Appendix: Previously Reviewed Baseline Upgrade Recommendations for the July 2021 PJM Board Review

Note: Items presented at the June 2021 TEAC & SRRTEP(s) will also be recommended for Board approval.

Changes for Existing Projects

ComEd Transmission Zone: Baseline Waukegan 138kV Substation

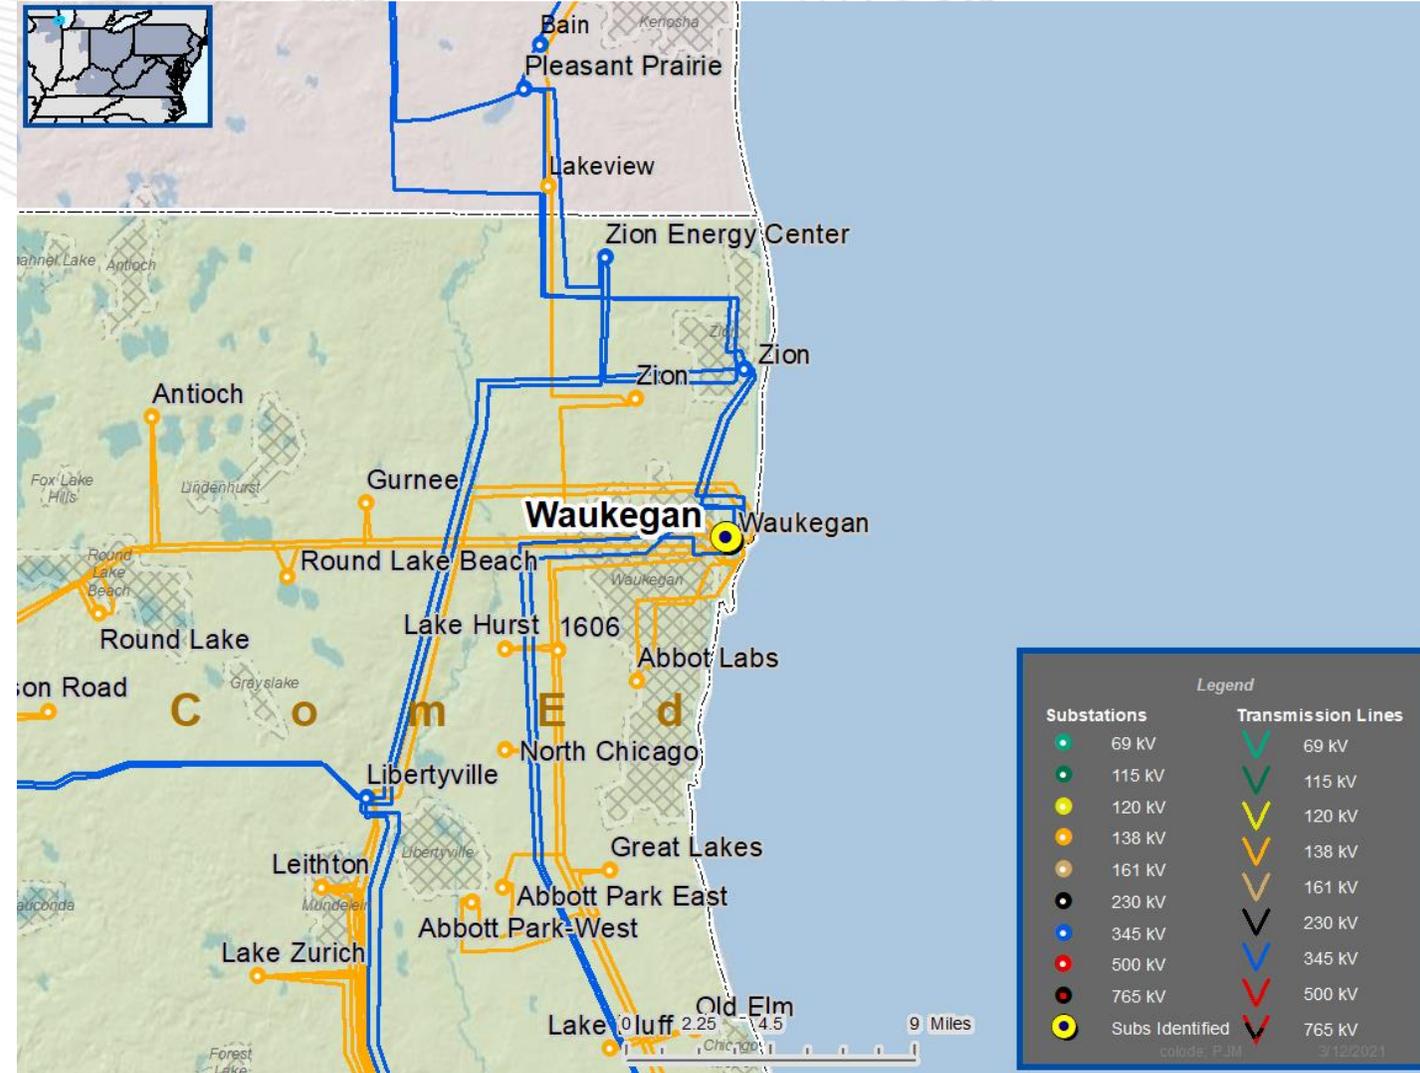
Mitigate existing instabilities at 138kV STA16 Waukegan for close-in three-phase faults with breaker failure. ComEd has been using out-step-relay as a temporary solution. A permanent solution is needed.

Modify backup relay clearing times at the 138kV STA16 Waukegan station. (B3317)
